### REMARKS

**PER-005-PAP**  
**Appl. No. 10/658,154**

**Reply Date: April 1, 2005**  
**Reply to Office Action of December 1, 2004**

*FIG. 1*

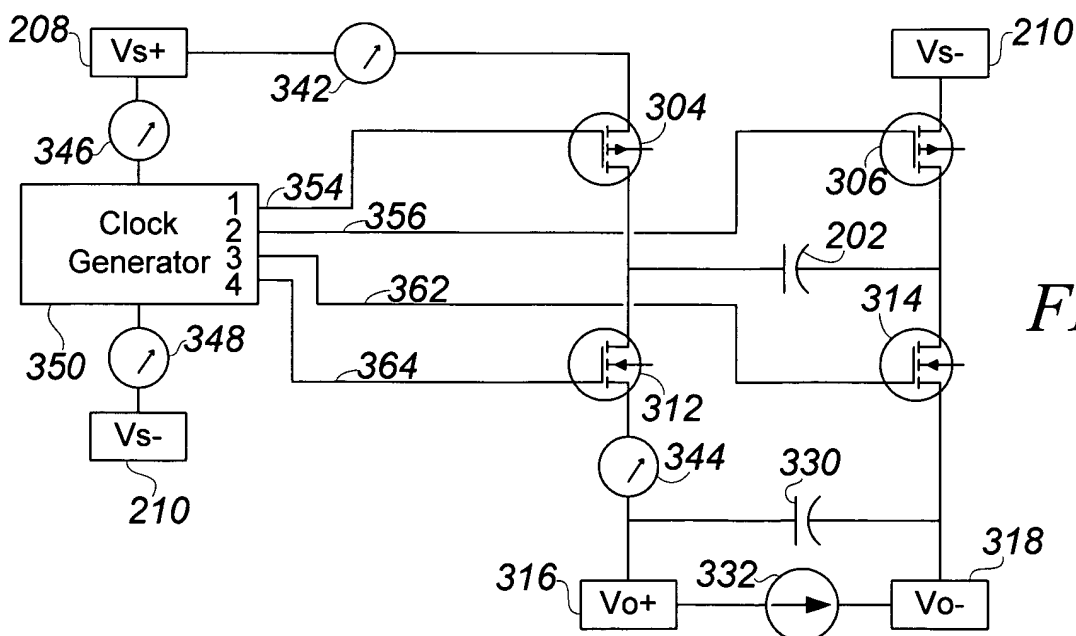
In a "Drawings" section of the current Office Action, the Examiner suggests that Figs. 1-2 should be designated --Prior Art--. FIGURE 1 is herein amended accordingly, but the Applicants respectfully decline to label FIGURE 2 as prior art. The figure suggests a flexible architecture, which, for example, permits a single "fly" capacitor to provide charge to an essentially unlimited number of distinct outputs, and contains material that is not known to be in the prior art. The architecture is "basic" only in that it omits switching details.

Figure 1 has been amended in response to the Examiner's objections thereto by addition of the term "Prior Art" as requested. A replacement first drawing sheet incorporating these changes, together with an annotated first drawing sheet showing changes in red, are attached to this response as an appendix.

(PRIOR ART)
